RESPONSE TO REQUEST FOR ADDITIONAL INFORMATION

APR1400 Design Certification

RAI No.: 116-8054

Question No. 14.03.08-11

Table 2.8-2

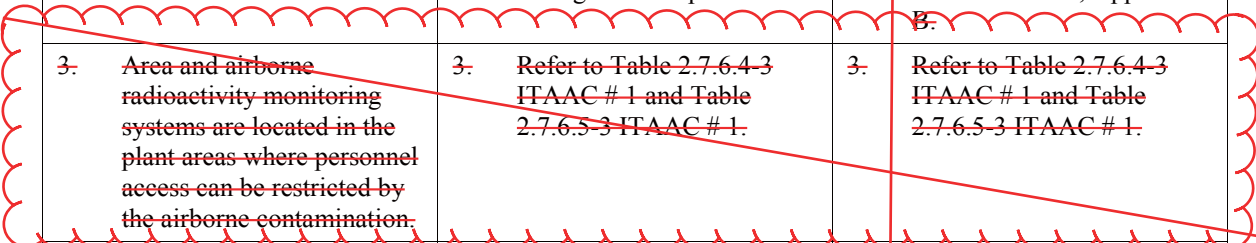
1. Item 2 in Table 2.8-2, indicates that an analysis will be performed to ensure that airflow is from areas of lower potential airborne contamination to areas with higher potential airborne contamination. The acceptance criteria states, "Analysis exists and concludes that ventilation airflows are from the lower potential airborne contamination area to the higher. The concentrations of airborne radionuclides are in the limit specified in 10 CFR Part 20, Appendix B." Staff believes that the intent of the acceptance criteria is to say that an analysis exists and concludes that ventilation airflow in radiological controlled areas flows from areas of lower potential airborne contamination to areas of higher

potential airborne contamination and that the concentrations of airborne radionuclides shall not exceed the concentrations provided in 10 CFR Part 20, Appendix B. Please revise the acceptance criteria, as appropriate.

2. Item 3 in Tier 1, Table 2.8-2 refers to other ITAAC in Tier 1 Tables 2.7.6.4-3 and 2.7.6.5-3 and is confusing to staff. It does not appear to provide any new acceptance criteria or requirements beyond what is provided in Tier 1, Tables 2.7.6.4-3 and 2.7.6.5-3. Please explain why item 3 in Table 2.8-2 is necessary or delete it.

1. The acceptance criteria for ventilation systems for the radiological controlled areas, ITAAC Item 2 in Table 2.8-2, will be revised to state that an analysis exists and concludes that ventilation airflow in radiological controlled areas flows from areas of lower potential airborne contamination to areas of higher potential airborne contamination. The concentrations of airborne radionuclides shall not exceed the concentrations provided in 10 CFR Part 20, Appendix B.
2. ITAAC Item 3 in Table 2.8-2 will be deleted since it is repetitive to other ITAAC in Tier 1 tables and does not provide any new acceptance criteria or requirements.

DCD Tier 1 Table 2.8-2 will be updated as indicated in the Attachment.

Analysis exists and concludes that ventilation airflow in radiological controlled areas flows from areas of lower potential airborne contamination to areas of higher potential airborne contamination. The concentrations of airborne radionuclides shall not exceed the concentrations provided in 10 CFR Part 20, Appendix B.
